SHEARON HARRIS NUCLEAR POWER PLANT, UNIT NO. 1  
DOCKET NO. 50-400/LICENSE NO. NPF-63

FREQUENTLY ASKED QUESTIONS (FAQS), REQUESTING ADDITIONAL  
GUIDANCE OR CLARIFICATION REGARDING TRANSITION TO NFPA-805  
"PERFORMANCE BASED STANDARD FOR FIRE PROTECTION FOR LIGHT  
WATER REACTOR ELECTRIC GENERATING PLANTS"

FAQ 06-0004

**NFPA-805 Transition Pilot Plant  
Frequently Asked Questions  
(Template)**

Figure B-1 – Process for Determining if an Active Fire Protection Feature is Required for NFPA 805 Chapter 4 Compliance

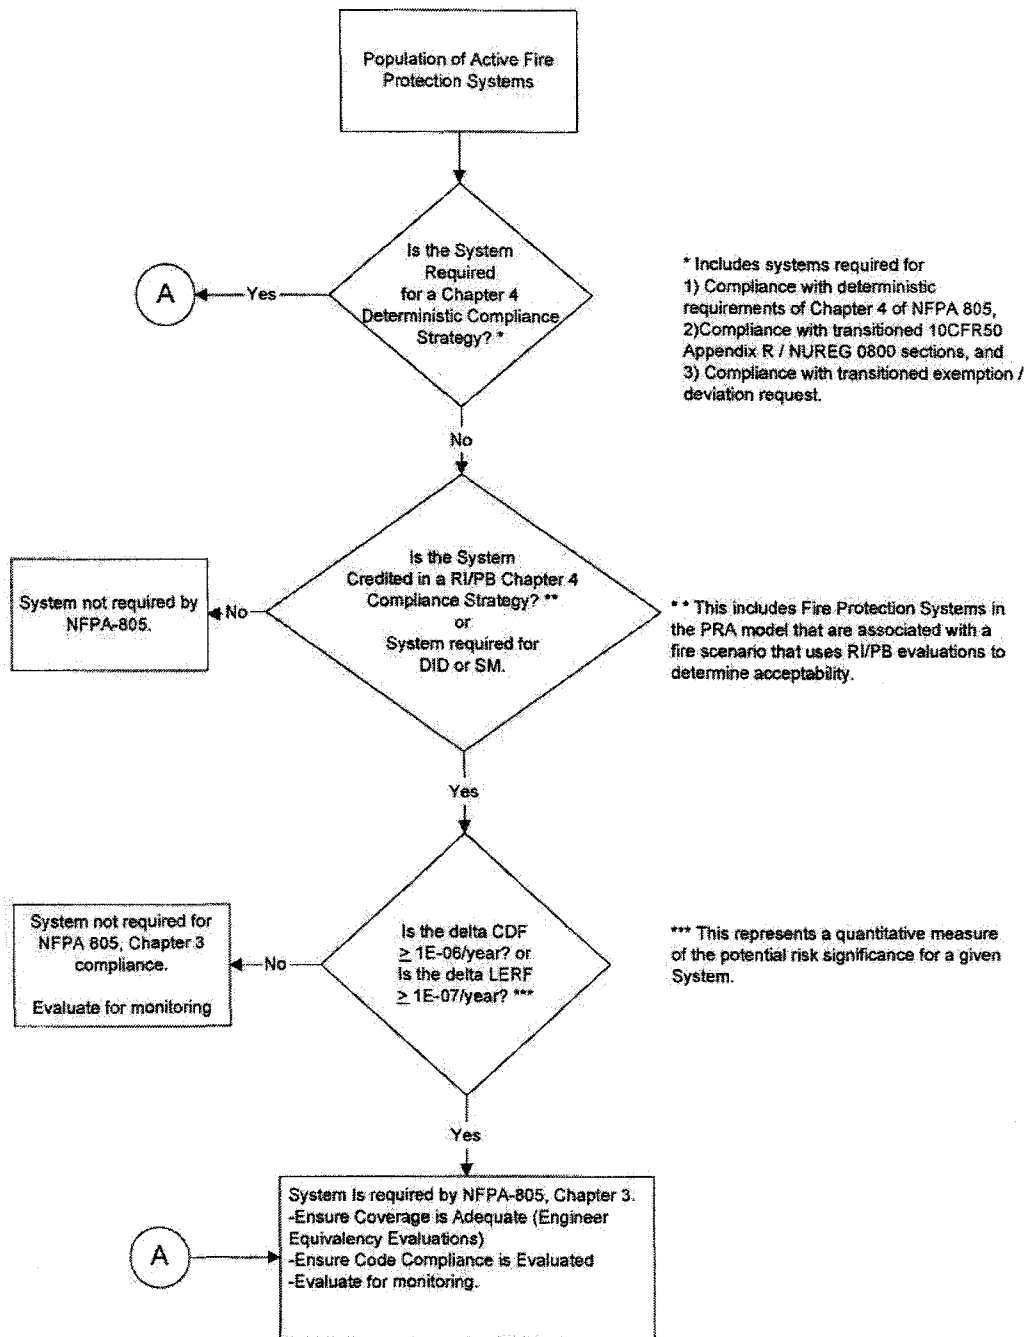
*Revised NEI 04-02 Section 5.3.2.4 and Appendix B to include more discussion of requirements for protection and flowcharts (in App. B) to assist in determining which systems and features are 'required' by Ch. 4 of NFPA 805. Certain systems, ERFBS, and fire rated barriers may be required to maintain the configurations assumed during the PRA or are necessary for Defense-in-Depth (DID) or Safety Margin (SM). Therefore, "Evaluate for Monitoring" was left in several flow chart sequences (Figures B-1, B-2, and B-3). Monitoring thresholds and criteria will be developed in detail during the Pilot Plant process.*

Certain Sections of Chapter 3 are only applicable if the fire protection feature is 'required' to meet the performance or deterministic requirements of Chapter 4. Determining if a fire protection feature is required is an iterative process. Figures B-1 through B-3 depict processes that may be used to determine if the requirements of Chapter 3 are applicable to a particular fire protection feature.
